Proposal to amend Working Document GRPE/2024/20 for the original Series of Amendments to Regulation No. 168

This document proposes to amend the scope of UN Regulation No. 168 to allow type approval of vehicles that previously were only within the scope as an extension based on their reference mass. The modifications to the current text of the Regulation are marked in bold for new or strikethrough for deleted characters.

Annex 3, amend to read:

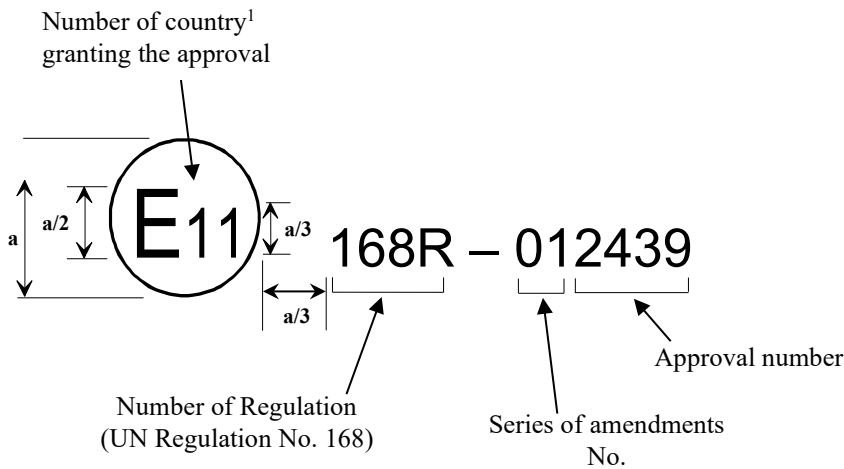
~~"In the approval mark issued and affixed to a vehicle in conformity with paragraph 5. of this Regulation, the type approval number shall be accompanied by an alphanumeric character reflecting the level that the approval is limited to.~~

This annex outlines the appearance of this mark and gives an example how it shall be composed.

The following schematic graphic presents the general lay-out, proportions and contents of the marking. The meaning of numbers and alphabetical character are identified, and sources to determine the corresponding alternatives for each approval case are also referred."
